Delegated Action of the Executive Director

PROJECT Kennedy Center Expansion Lightning Protection System Kennedy Center for the Performing Arts 2700 F Street NW Washington, DC	NCPC FILE NUMBER 7523
SUBMITTED BY Kennedy Center for the Performing Arts	NCPC MAP FILE NUMBER 3.10(38.00)44842
	ACTION TAKEN Approve as requested
	REVIEW AUTHORITY Approval Per 40 U.S.C. § 8722(b)(1) and (d)

Figure 1: Site Plan of Kennedy Center Expansion with Lightning Protection masts identified

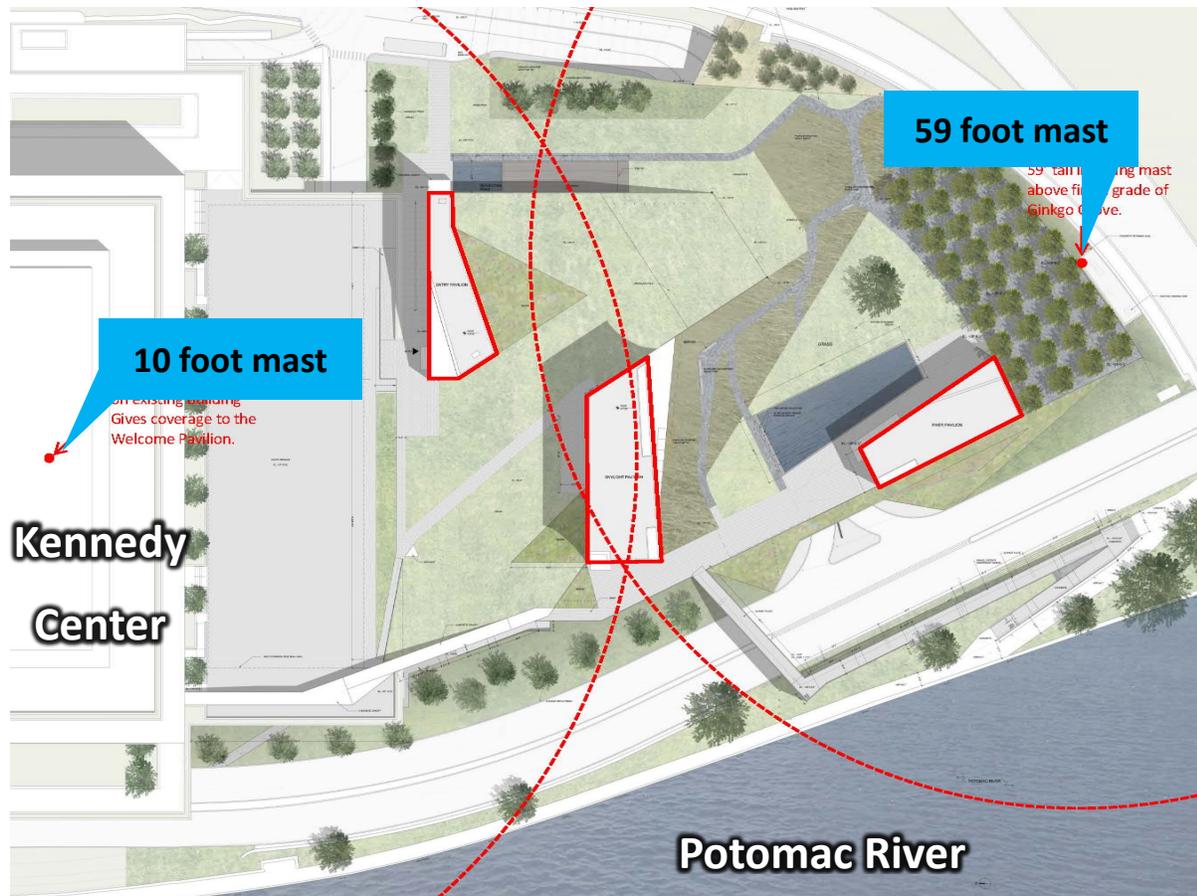
In order to provide maximum coverage with minimal visual impact, the engineering of the system resulted in the specification of two distinct masts. One mast will be 10’ tall, made of milled aluminum, tapered from four inches at the base to three inches at the top, and mounted on the upper roof of the Kennedy Center’s original building, providing coverage to the north end of the REACH, including the plaza and upper lawn. The second mast, made of galvanized steel, will be mounted to the base of a new retaining wall at the south end of the REACH site, within the new grove of ginkgo trees. It will be 59 feet in height above the finished grade of the ginkgo grove and six inches in diameter at the base, tapering to three and a half inches in diameter at the top. This mast will protect the bulk of the REACH campus including the lower lawn and the two southernmost pavilions. The applicant notes it is positioned on the Kennedy Center property

nearest to the Theodore Roosevelt Bridge access ramp to enable it to blend in with the existing signs and lampposts.
